SUBJECT: No Additional ESA or EFH Consultation Needed for Design Refinements  
to the Grand Bay Intertidal and Subtidal Reef Project, Phase IV Early  
Restoration, Mississippi

## **Restoring Living Shorelines and Reefs in Mississippi Estuaries**

### **Grand Bay Intertidal and Subtidal Reef Component**

**March 15, 2019**

*Figure 3: Conceptual project design proposed in the 2015 Final Biological Evaluation, Proposed Subtidal Reefs not within Gulf Sturgeon Critical Habitat*

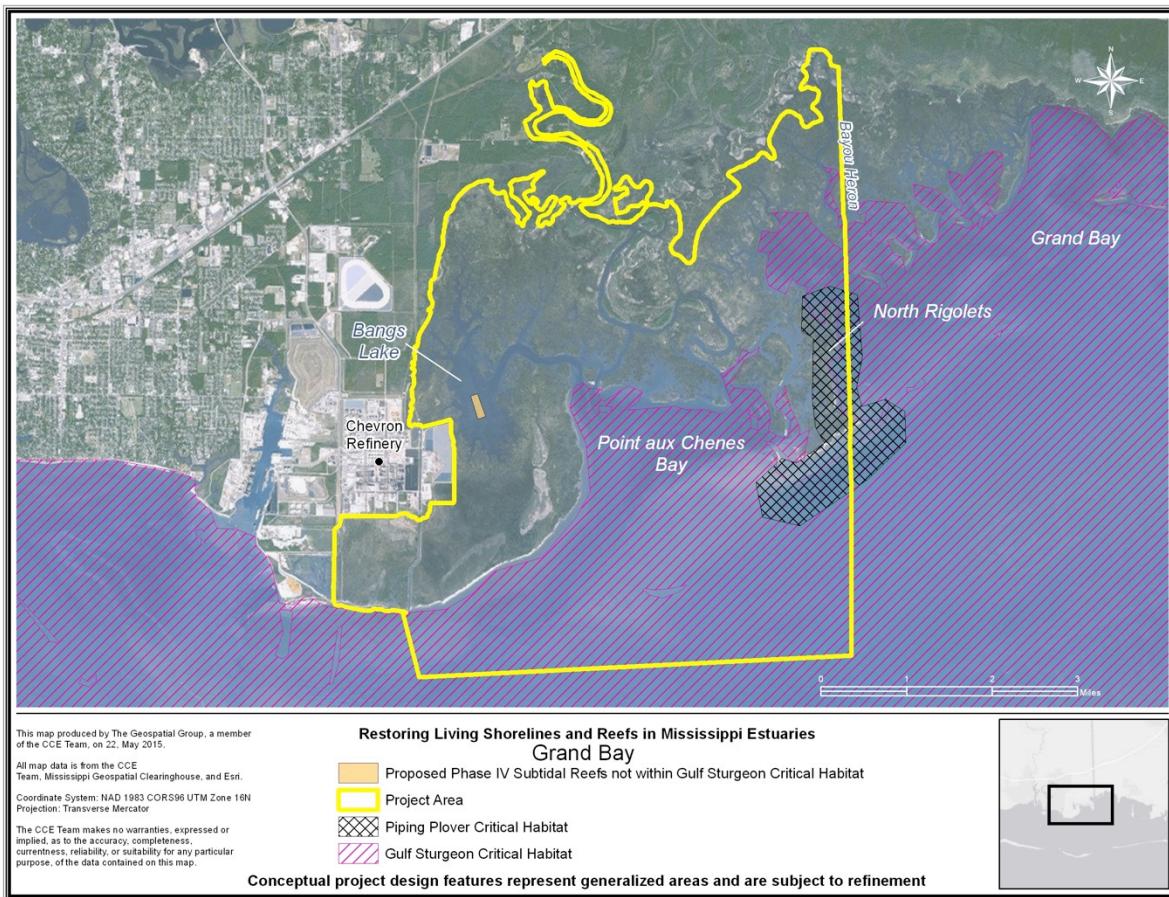
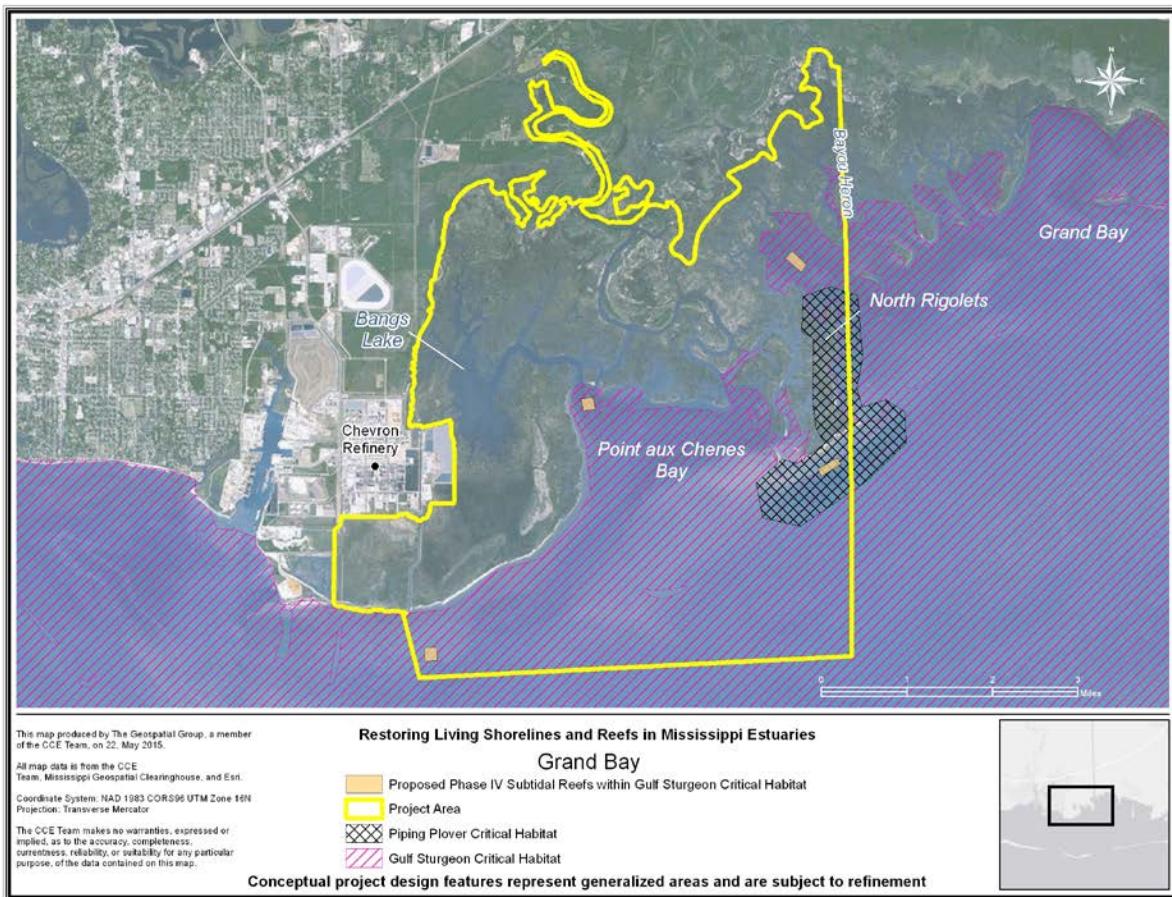
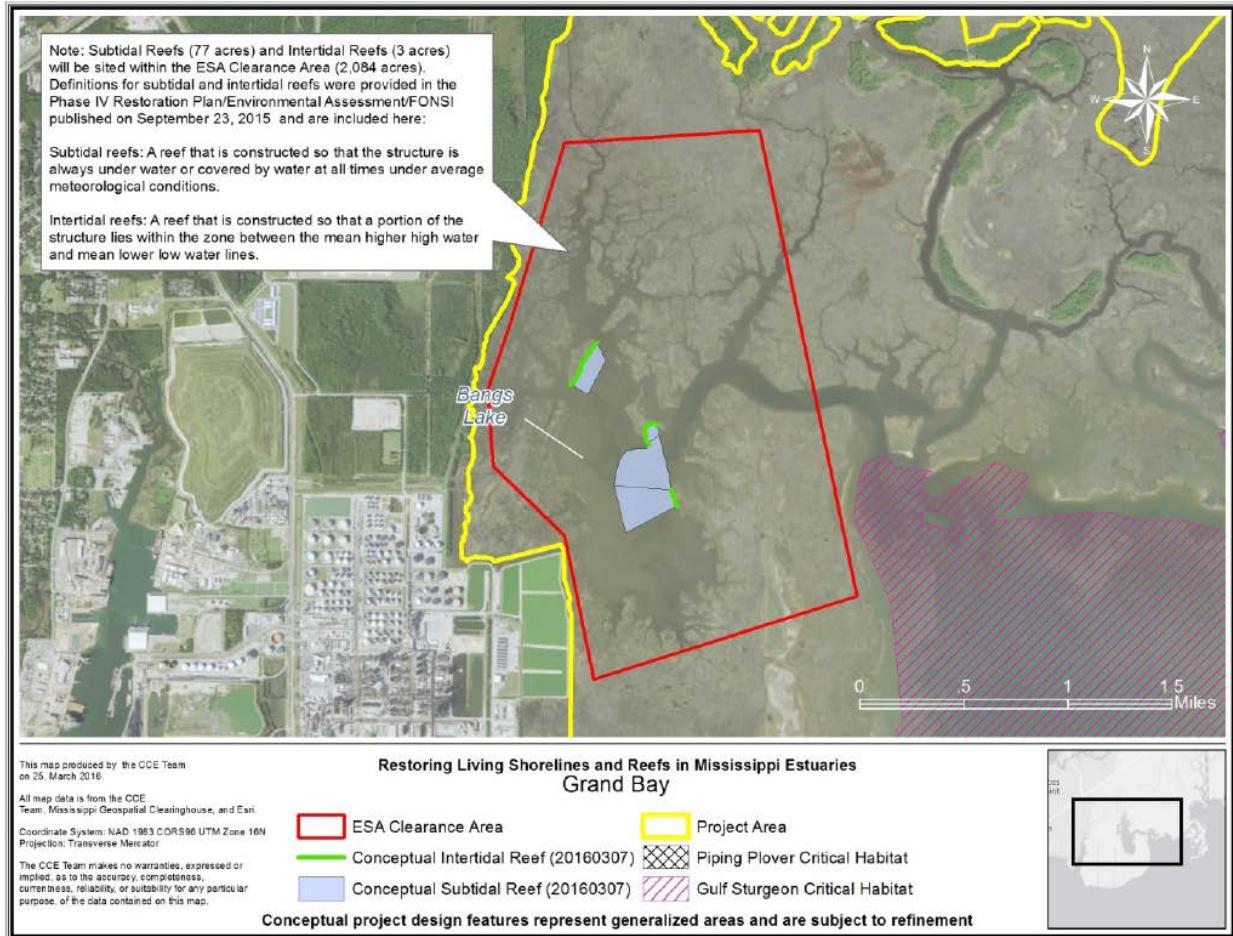
ESA consultations for the Grand Bay Subtidal Reefs and Grand Bay Intertidal Reefs were previously coordinated with NOAA NMFS (SER-2015-16955 and SER-2015-16990) and USFWS (2015-I-793) in 2015 and 2016. EFH consultations were coordinated with NOAA NMFS in 2015. The 2015 Biological Evaluations included intertidal and subtidal reef locations located both within and outside of Gulf Sturgeon Critical Habitat. In 2016, additional design refinements resulted in the anticipated locations of reef locations in Bangs Lake (out of Gulf Sturgeon Critical Habitat). Since that time, due to various constraints, the reef locations have shifted again, and geotechnical and bathymetric studies and subsequent engineering design has been conducted for the project. The Final Basis of Design Report includes the placement of a maximum of 3 acres of intertidal reef in Bangs Bayou (outside of Gulf Sturgeon Critical Habitat) and a maximum of 6.5 acres on the western side of Point Aux Chenes Bay (in Gulf Sturgeon Critical Habitat). Please note that the new final design reduces subtidal reef acreage from 77 acres to a maximum of 6.5 acres.

Project Element	Parameters	2015 BE	2016 BE	Current Design
Subtidal Reef	<b>Acreage</b>	Up to 77 acres in Bangs Lake or in and adjacent to Grand Bay	up to 77 acres in Bangs Lake	6.5 acres (maximum) Point Aux Chenes Bay
	<b>Gulf Sturgeon Critical Habitat</b>	Some areas in GSCH and some areas not in GSCH	No	Yes
	<b>Construction materials</b>	Approved cultch material (limestone, crushed concrete, oyster shells or combination thereof)	Limestone, crushed concrete, oyster shells or a combination thereof	Aggregate (stone or processed concrete), native shell, and shell hash
	<b>Thickness</b>	1 – 12 inches	1 – 12 inches	0.2 foot to 3.0 feet in undulating ridges
	<b>Volume of materials</b>	62,139 cubic yards	62,139 cubic yards	Up to 8,000 cubic yards
	<b>Substrate</b>	Unconsolidated soft and hard bottom (sand, muddy sand, mud bottom and remnant reef)	Unconsolidated soft and hard bottom (sand, muddy sand, mud bottom and remnant reef)	Sand or firm clays, with some areas having up to 1.5 feet of soft sediment, underlain by a marine clay bearing layer.

<b>Water depth</b>	0 – 10 feet below MLLW	No greater than 10 feet below MLLW	- 2.0 ft to - 5 ft below MLLW

*Figure 7: Current Design Grand Bay Subtidal Reef in Plan View*

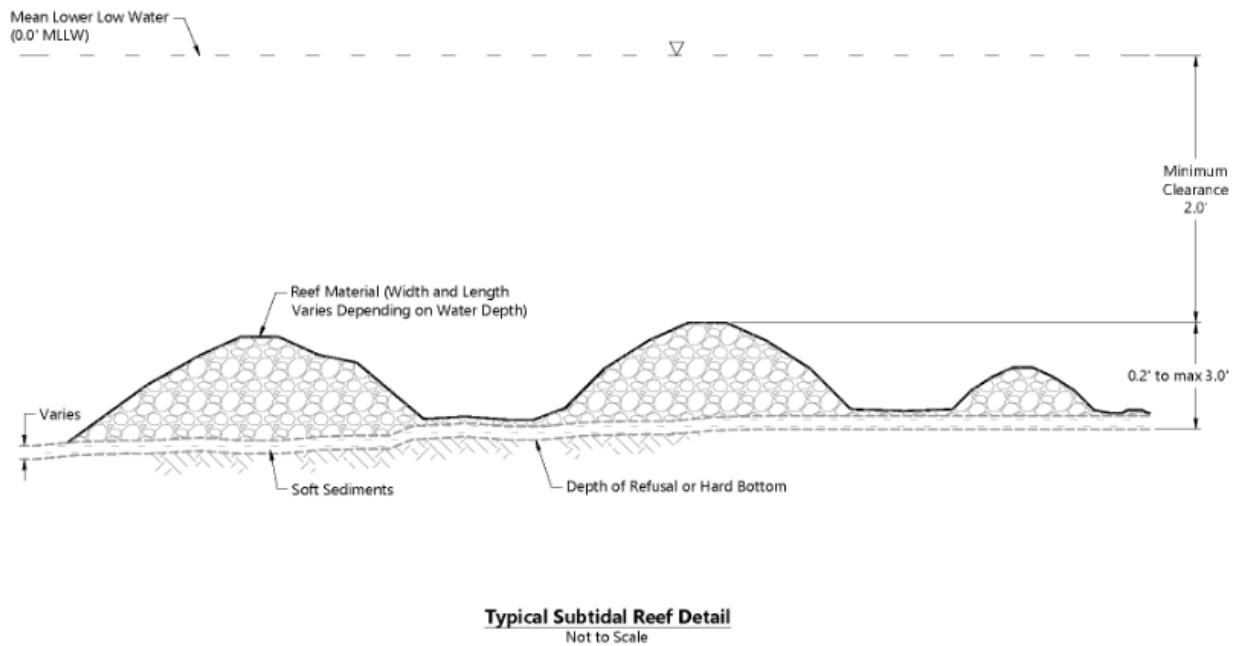
Proposed Subtidal Reef Polygons (total 35 acres) in which 6.5 acres (maximum) will be located and constructed in water depths between the 2.0 and 5.0 foot MLLW contours.

Figure 10: Current Design Grand Bay Intertidal Reef in Profile View

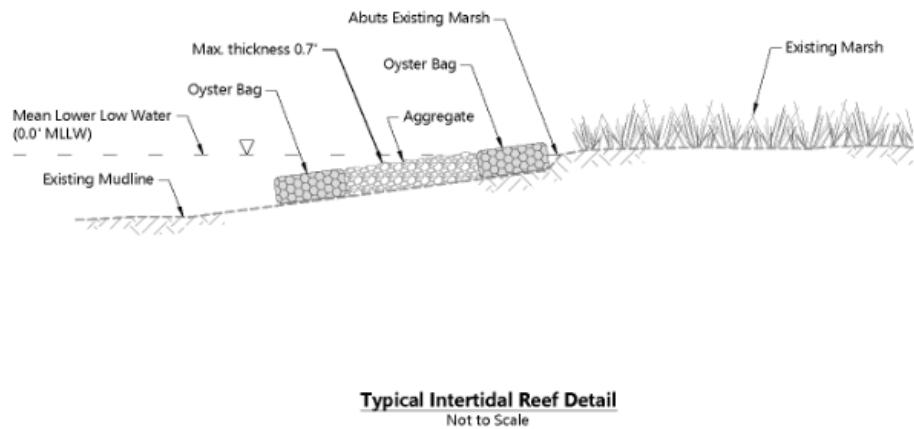
Project Element	Parameters	2015 BE	2016 BE	Current Design
Intertidal Reef	<b>Acreage</b>	Up to 3 acres in Grand Bay Estuary in multiple waters including Bangs	Up to 3 acres in Bangs Lake	Up to 3 acres in Bangs Bayou

Bayou and Bayou Heron		
<b>Gulf Sturgeon Critical Habitat</b>		Some areas in GSCH and some areas not in GSCH	No	No
<b>Construction materials</b>		Loose or bagged oyster shells	Loose or bagged oyster shells	Oyster bags and aggregate (stone or processed concrete). Oyster bags will be constructed of carbon steel wire mesh and filled with oyster shell and aggregate (stone or processed concrete).
<b>Volume of materials</b>		2,420 cubic yards	2,420 cubic yards	Up to 2,500 cubic yards
<b>Substrate</b>		Soft bottom sands and mud	Unconsolidated soft and hard bottom (sand, muddy sand, and mud bottom)	Sand or firm clays with a thin veneer of silt and silty sands, with some areas having up to 1.5 feet of soft sediment, underlain by a marine clay bearing layer
<b>Water depth</b>		Between MLLW and MHHW	No greater than 6 feet below MLLW	-0.5 ft to +1.5 ft MLLW
